FIELD SAFETY NOTICE

PREVENTIVE CORRECTIVE ACTION CONCERNING SCHAEERER ARCUS 501-701 SURGICAL TABLES

Figure 1: Large Valve Block arcus

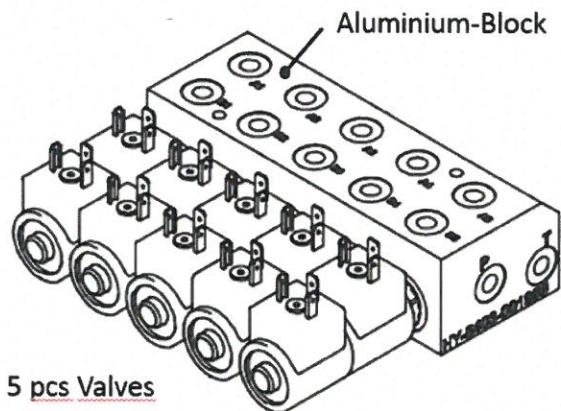
With this letter, we inform you about a potential issue concerning the hydraulic system of the Schaerer Arcus 501-701 surgical tables. Every Schaerer arcus 501, 601 or 701 surgical table is equipped with a large hydraulic valve block (see figure 1) which is mounted on the upper part of the column of the table (see figure 2). This valve block is designed to control and coordinate the various hydraulic movements of the surgical table. The potential defect of the valve block may result in slow movements or complete stop of the table.

During routine quality control procedures of the large valve block at the supplier's factory, inaccurate, out of spec drill holes were discovered. The drill holes serve as positioner for the hydraulic valves, which control the flow of hydraulic oil through the hydraulic system and thus the movements of the components of the table, such as height column, lateral tilt, Trendelenburg, seat section and leg section.

The inaccurate drill holes may result in damage of the valves, which may result in malfunction of the table. Damaged valve sealing may result an uncontrolled flow of hydraulic oil which may result in a loss of pressure in the hydraulic tubes and subsequently the cylinders are not controlled correctly

Every customer will be contacted by the Schaerer Medical Customer Service and the affected large valve blocks will be replaced/ exchanged. Please keep this FSCA Information on file at least until the measures taken are fully completed.

Schaerer Medical will provide replacement parts and instructions for the replacement. Please contact the customers according to the serial numbers and ensure the replacement of the large valve blocks in due course.
